# UNITED STATES PATENT AND TRADEMARK OFFICE

APPLICATION NO.	FILING DATE	FIRST NAMED INVENTOR	ATTORNEY DOCKET NO.	CONFIRMATION NO.	
10/826,867	04/16/2004	Mark Colman	14389.2USU1	1444	
75	90 10/12/2006		EXAMINER		
Merchant & Gould P.C.			STERLING, AMY JO		
P.O. Box 2903					
Minneapolis, MN 55402-0903			ART UNIT	PAPER NUMBER	
			3632		
			DATE MAILED: 10/12/2006

This is the **Final Office Action** for application number for application number 10/826,867, Extendable/Retractable Support Column, filed on 4/16/04. Claims 1-6, 10-19 are pending.

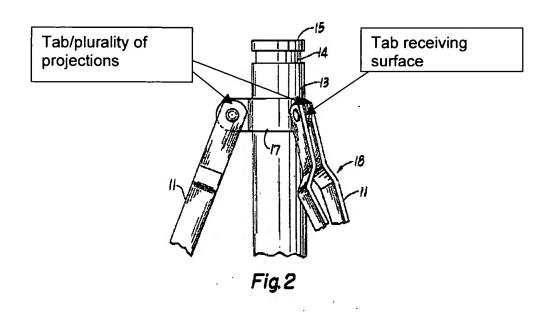
Claims 1, 10 and 16-18 are rejected under 35 U.S.C. 102(b) as being anticipated by United States Patent No. 3203657 to Thompson.

The patent to Thompson discloses a one piece integral structural unit having least three linked sections (11, 12), each linked section including a plurality of individual sections pivotally connected to one another in end-to-end relationship, each linked section having a surface parallel and spaced apart from the inner surface, the sections being positioned adjacent to at least two other linked sections, each individual section having an inner surface, a first end and a second end and a connection tab or plurality of projections (See Below) at the first end of the individual section, the connection tab extending inwardly of the inner surface of the individual section, and each individual section including a tab receiving surface (See Below) at the second end of the individual

section for engagement by the connection tab of an individual section of one of the adjacent linked sections.
